October 16, 2008  
LIC-08-0107

**SUBJECT: Notice of Completion of Corrective Actions Taken in Response to Generic Letter (GL) 2004-02 and Response to Request for Additional Information (RAI) for Fort Calhoun Station (FCS) Unit No 1**

Omaha Public Power District's Response to  
Request For Additional Information

Supplemental Response To Generic Letter (GL) 2004-02

Figure 1 – Flow streamlines in the containment pool illustrated by releasing massless particles from Compartments A and B (Case 6, Break B)

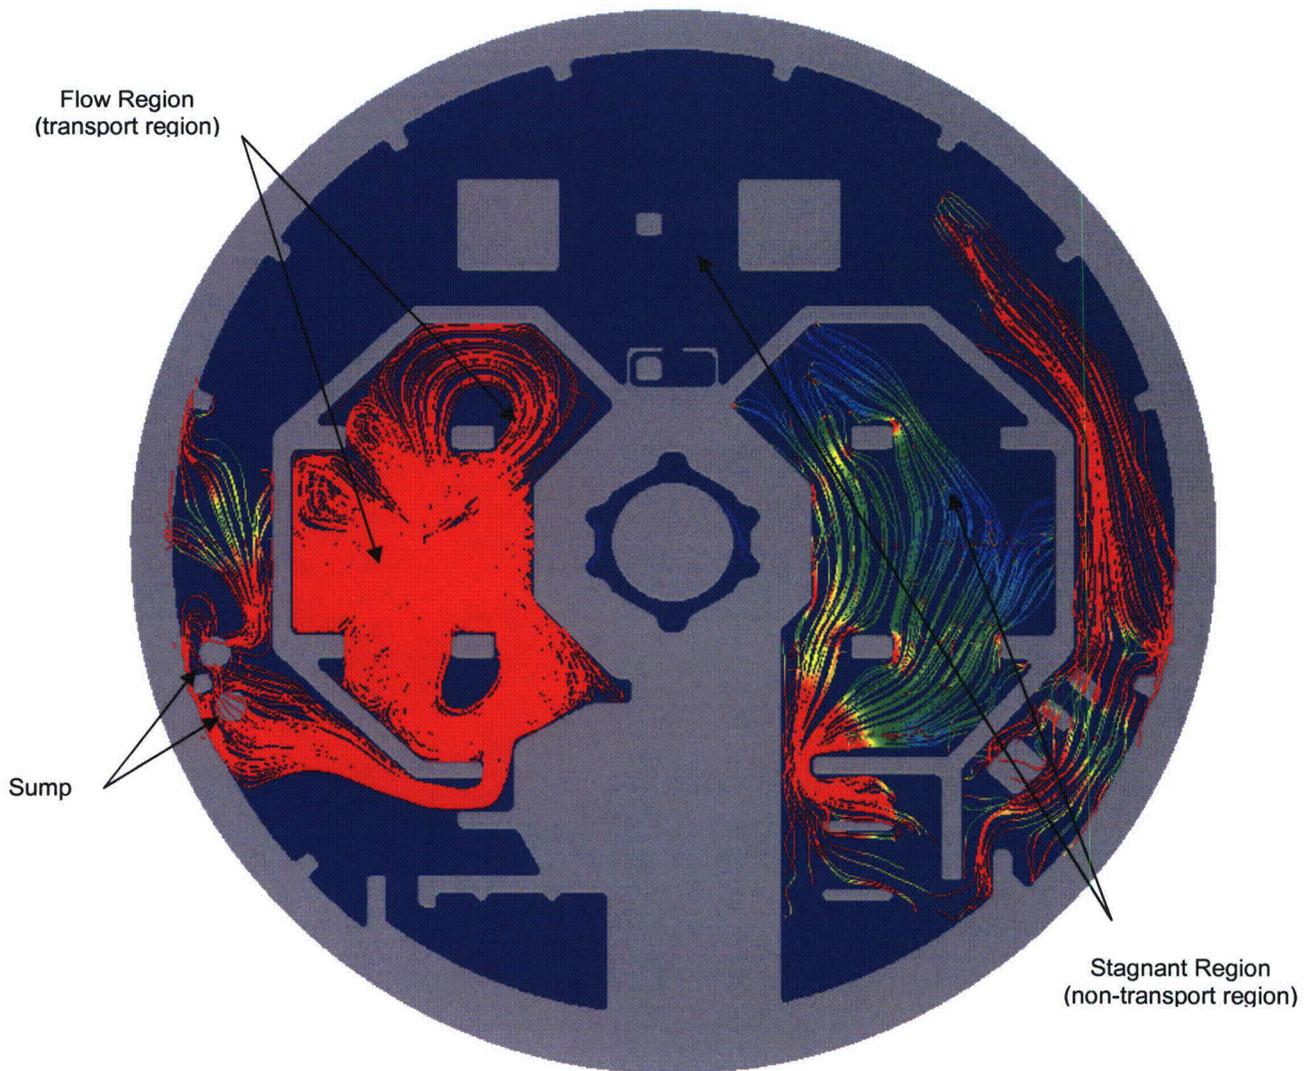
7. **Given all the uncertainties involved with condensation wash down over a 30-day period and the distribution of debris in containment following blowdown, please provide the technical basis for the assumption of 5% wash down transport for fibrous debris and coatings from upper containment (and potentially for other fine debris such as calcium silicate particulate). NUREG/CR-6762 Vols. 1 and 4 consider 5% wash down a favorable estimate for minimizing transport and consider 10% an unfavorable estimate. The estimated wash down fractions used in NUREG/CR-6762 as well as Appendix VI to the staff's SE were ultimately based on NUREG/CR-6369, which indicates that directly applicable experimental data for condensate (from steam in the containment atmosphere) drainage transport is non-existent and that the wash down fractions therein are essentially based on engineering judgment. This suggests that use of the 10% estimate might be more appropriate.**

The debris generation calculation determined that the largest debris load is created by a break in A SG bay. The CFD model shows that for such a break, the only active transport path is from the A SG, while the B SG cubicle is a stagnant area. (See Figure 9 on page 43 of the supplemental response LIC-08-0021). Any wash down due to condensation from the CACFS will increase the debris in or around the B SG cubicle, but will not be entrained in the flow path from the A SG break. A break in B SG (See Figure 1 below) results in a smaller debris load and an increase in the wash down from 5%, as assumed in the transport calculation, to 10%, as suggested by the RAI, is still bounded by the debris load from A SG case for which the strainer was tested.

In addition, as stated on page 62 (last paragraph) of the supplemental response (LIC-08-0021), the testing modeled the “B” sump strainer because of the higher flow rates that could be associated with this strainer (two HPSI pumps), while conservatively using the higher debris loads associated with the “A” strainer. Based on these assessments, a condensation wash down to the pool of 5% is considered conservative.

Figure 4-1 Fort Calhoun Replacement Suction Strainer Assembly  
Finite Element Model

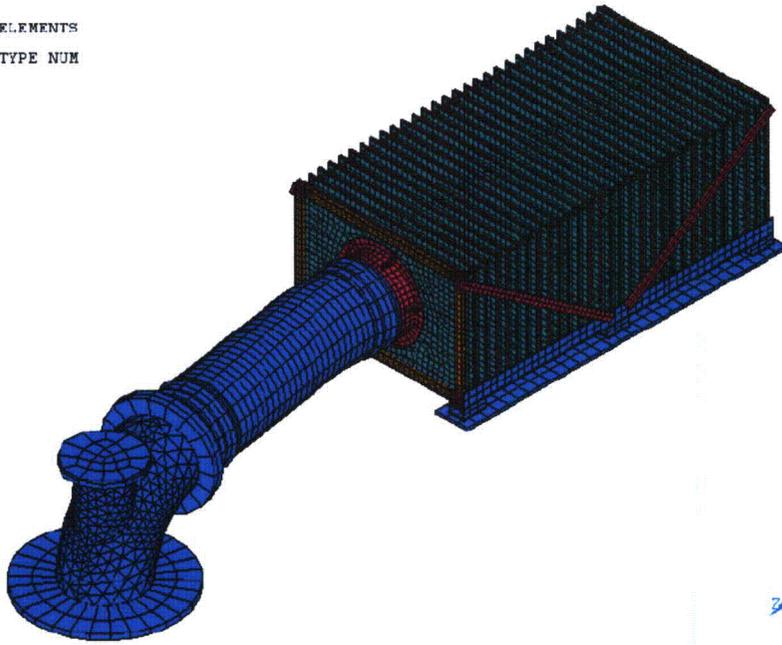
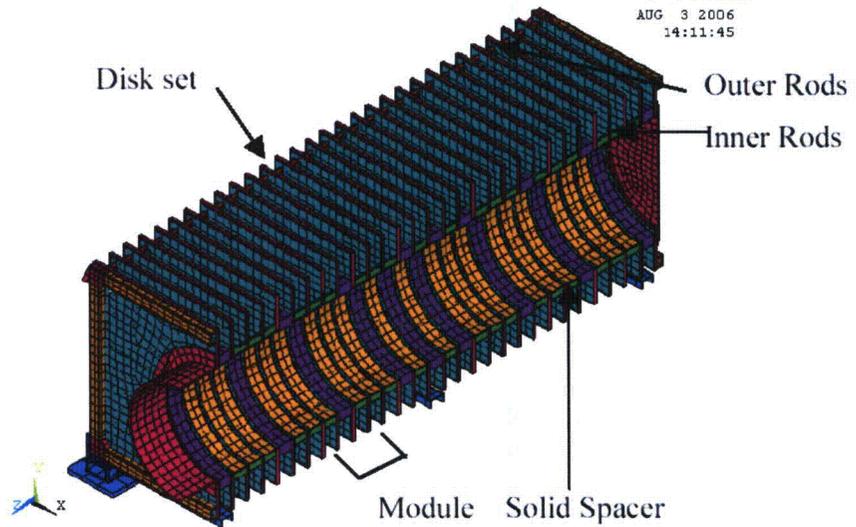
- 28. The Revised Content Guide for GL 2004-02 requests a summary of the design inputs, loads, and load combinations utilized for the sump strainer structural analysis. The submittal which was provided contains a pointer or reference to a GE calculation which contains this information, but none of the actual information was summarized or provided. Please provide this summary information.**

The structural analysis utilizes the suction strainer assembly finite element model shown in Figure 4-1. The strainer assembly is modeled with solid elements (ANSYS Element Types 45 and 190). The strainer disks and spacer rings are composed of perforated plates with 1/16" diameter holes on a triangular pitch. The spacer rings are situated between the disks at the inner circle. The holes were not included in the integral strainer analysis model because of the model size limitation. Instead, the perforated plates are modeled with equivalent solid plates with modified material properties.

10M-SBLOCA-LDFG-Verified.xls

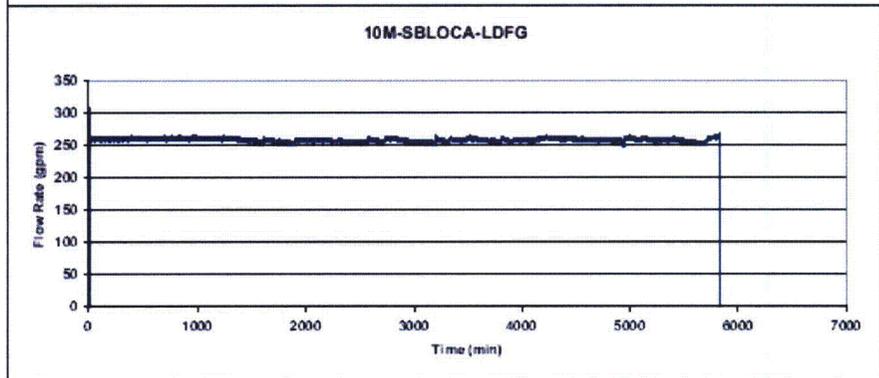
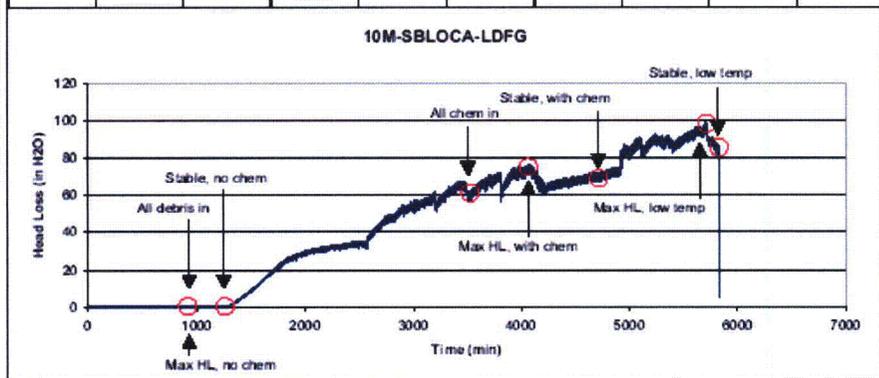
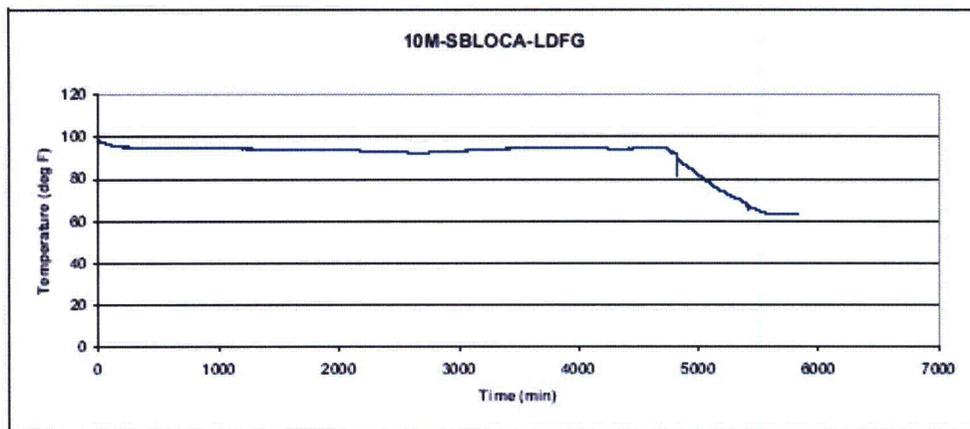
- 22. Please provide the test termination criteria and the methodology by which the final head loss values were extrapolated to the emergency core cooling system (ECCS) mission time or to some predicted steady-state value. Please include enough test data that the extrapolation results can be confirmed.**

11M-SBLOCA-Jacketed (design basis test) was terminated at approximately 2700 minutes and 101 turnovers were achieved at approximately 1700 minutes. Test 11M-SBLOCA-Jacketed was terminated based on a stable head loss and well after the plant-representative 101 water turnovers were achieved (See graph provided in Enclosure, Attachment 1).

10M-SBLOCA-LDFG (non-design basis test) was terminated at approximately 5800 minutes for a total of  $(5800/17) = 341$  turnovers; test 10M-SBLOCA-LDFG was terminated based on a stable head loss and well after the plant-representative 101 water turnovers were achieved (See graph provided in Enclosure, Attachment 1). Banding and jacketing of insulation have changed the plant debris loads such that 10M-SBLOCA-LDFG is no longer a representative case. 10M-SBLOCA-LDFG is not the design basis test and is presented for information only.
